Form 3160-5
(March 2012)UNITED STATES
DEPARTMENT OF THE INTERIOR
BUREAU OF LAND MANAGEMENT

FORM APPROVED
OMB No 1004-0137
Expires October 31, 2014**SUNDRY NOTICES AND REPORTS ON WELLS**
Do not use this form for proposals to drill or to re-enter an abandoned well. Use Form 3160-3 (APD) for such proposals.5. Lease Serial No
NMSF 079600
6. Indian, Allottee or Tribe Name

8. Well Name and No
CW Roberts Tank Battery Central Delivery Point

Four Star Gas & Oil Company proposes the following changes at the CW Roberts Tank Battery Central Delivery Point:

Current well site diagram CW Roberts Tank Battery Central Delivery Point

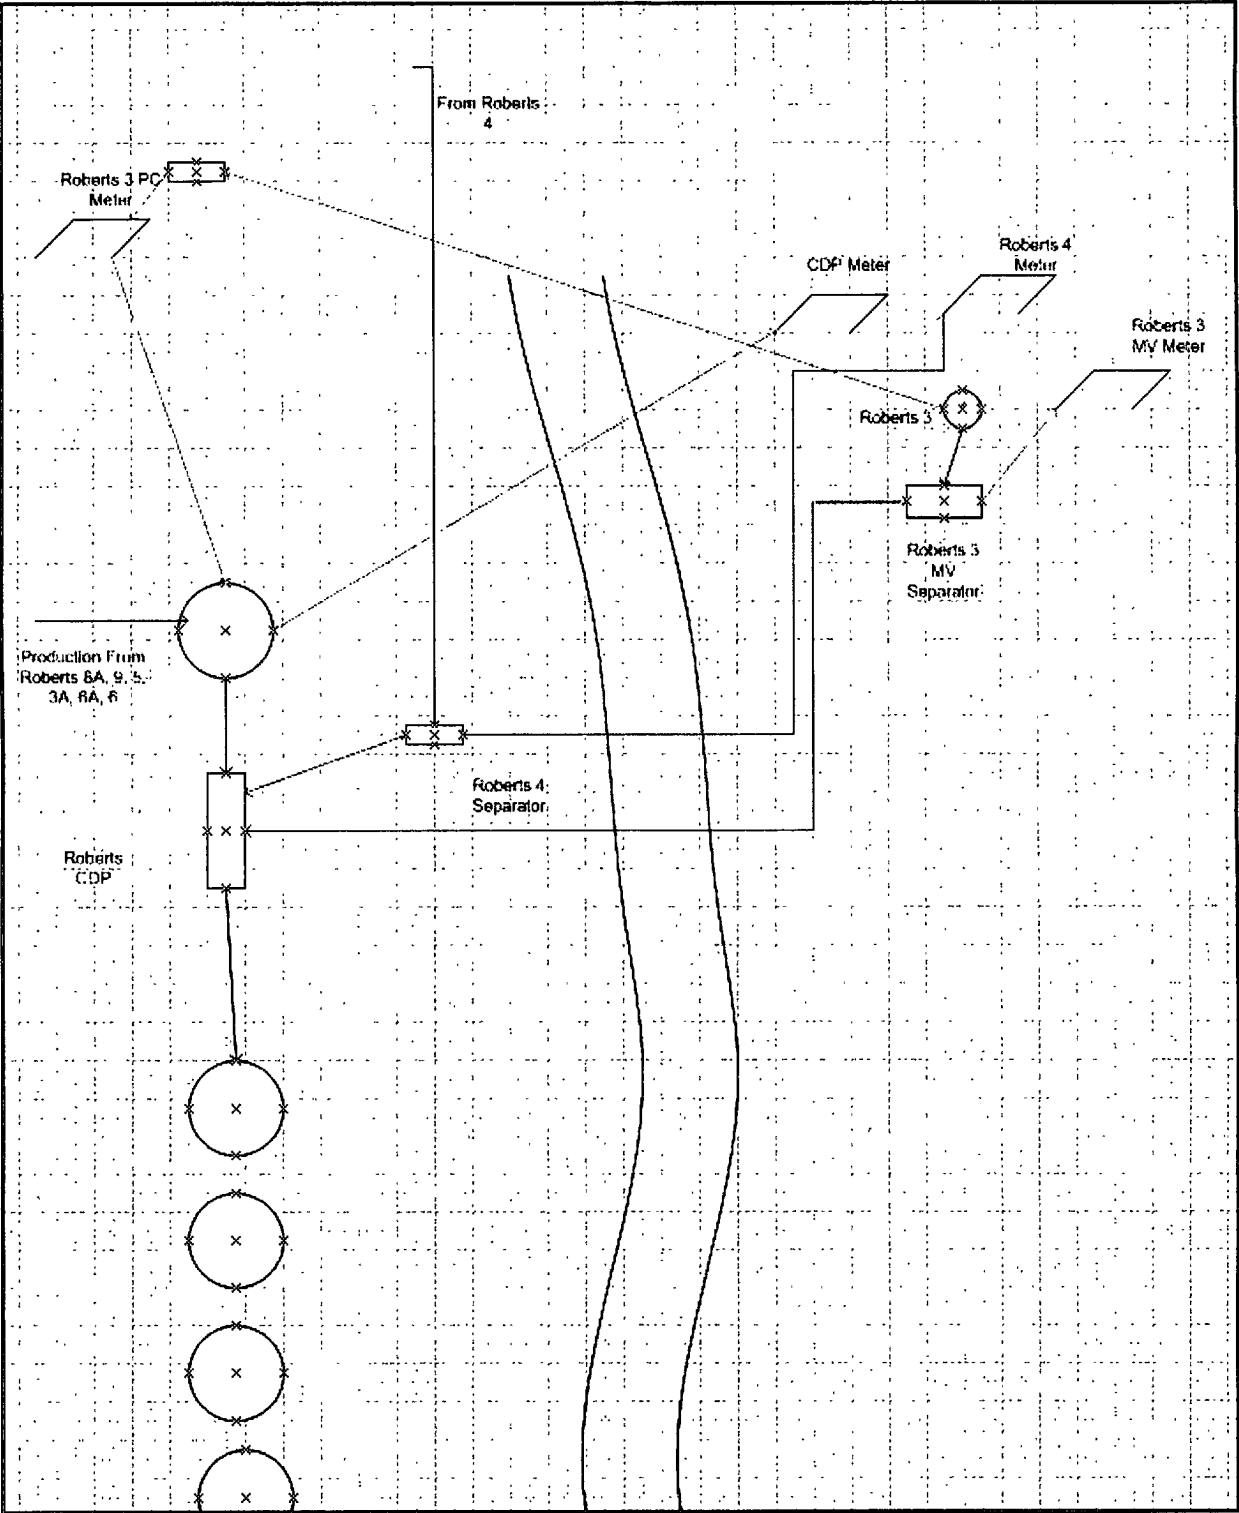
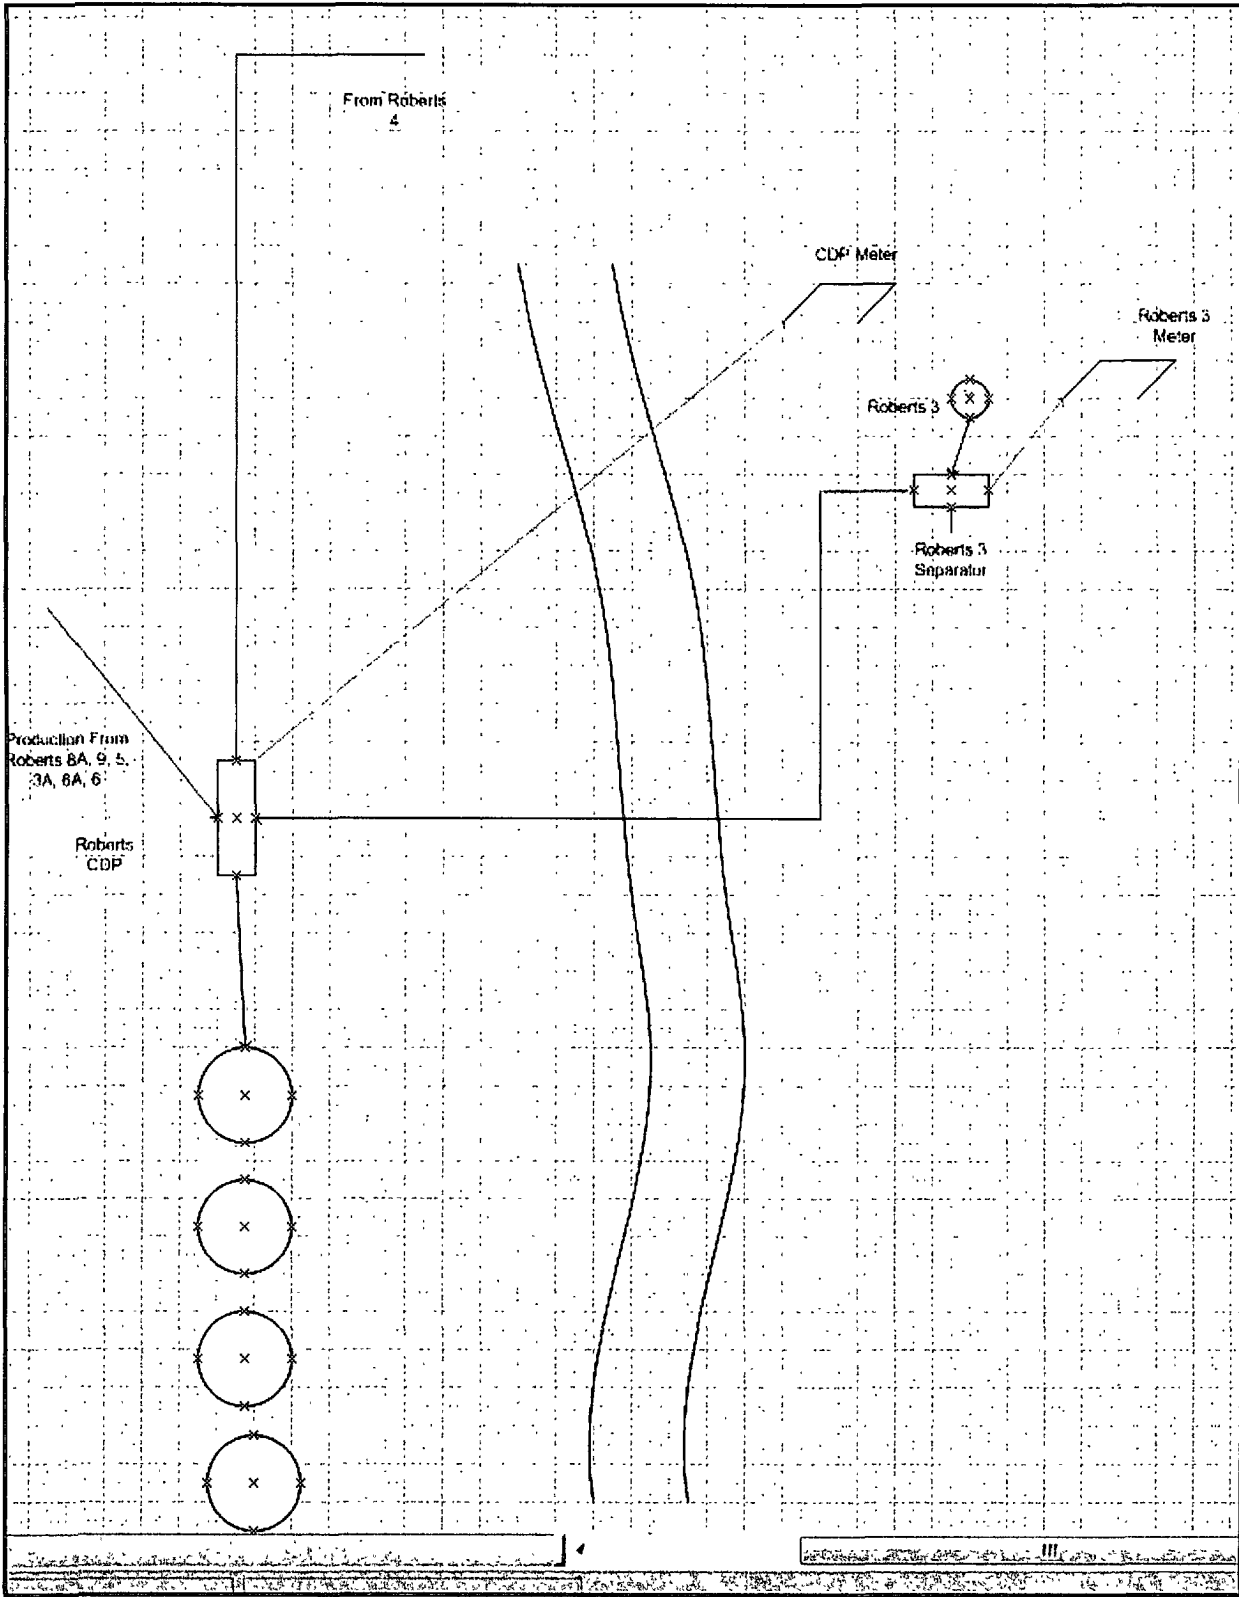
Currently, the Roberts 4 production goes through a small separator (just for the Roberts 4) at the Roberts Battery, then the fluids go to a horizontal separator for the whole CDP and the gas goes across the road and is sold at a meter at the Roberts 3 site.

The Roberts 3 MV is separated and metered on site, and the Roberts 3 PC goes across the road where it is metered and then is combined with the other Roberts production at the heater treater (which is then sent to the Roberts CDP meter, at the Roberts 3).

Four Star Gas & Oil is proposing to remove the Roberts CDP heater treater and horizontal separator, and replace with one horizontal 3 phase separator. We also plan to remove the Roberts 4 separator and send all Roberts 4 production to the new horizontal 3 phase (which means all Roberts 4 gas would be sold at the Roberts 4 meter). The meter change done at the Roberts Battery will remove the Roberts 4 Separator and tie the Roberts 4 into the CDP separator. This means the Roberts 4 will no longer be metered separately, but will be combined with CDP production. Production would only be tested annually with a test separator.

Proposed well site diagram CW Roberts Tank Battery Central Delivery Point
